Subject: Planned Development PD11-0005/S11-0009/ Green Valley Nursery

S11-0009/PD11-0005/Green Valley Nursery and Landscape; New Transportation

14-0386 Public Comment PC Rcvd 03-27-14

Head on Accident – Feb. 8, 2014

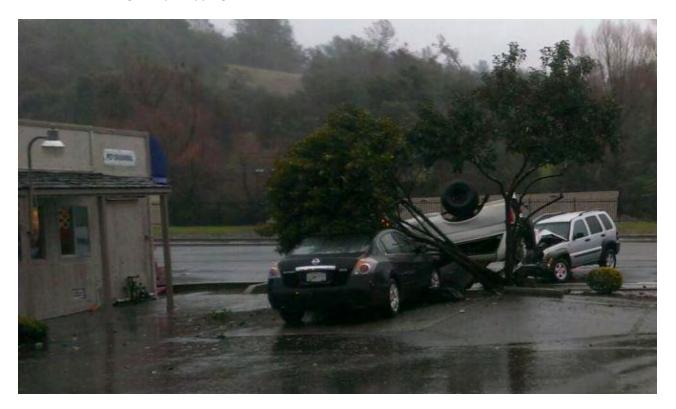
Below is a "real world" example of an accident that occurred on Feb. 8, 2014 on Green Valley Road just east of the intersection of Sophia Parkway. The photo depicts a head-on accident that flipped one vehicle onto its hood, took out a barrier tree that landed on a tenant's vehicle and nearly continued to slide into a building at my shopping center.

As I have described on numerous occasions in letters and live testimony to the El Dorado County Planning Commission and Board of Supervisors, accidents along this segment of Green Valley Road are becoming increasingly more frequent and exponentially more severe. This is a trending pattern that must be addressed before any more pressure from new business is added. It is not an acceptable strategy to build first and then architect a solution around it. Planning needs to be thorough and accurate in order to protect the collective community's interests and must be placed above the goal of generating new sales tax revenues.

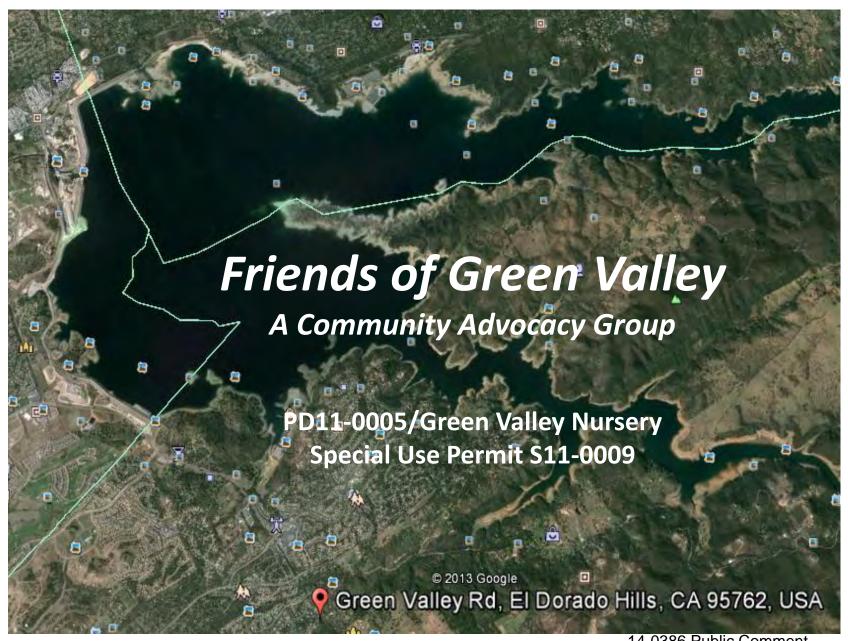
This project is requesting a reduction in wetlands setback from 50 feet to as little as nine (9) feet in some instances after illegally grading over 10,000 square feet of land without a permit. It seems to have become a pattern for the Planning Commission to simply approve arbitrary reductions in the required 50' wetland setback. This needs to stop! The citizens of El Dorado County are not supporting these decisions. This project has no compelling reason to approve a reduction in the setback, and it should be denied. The photos below illustrate a careless disregard for the stream running next to the Nursery's
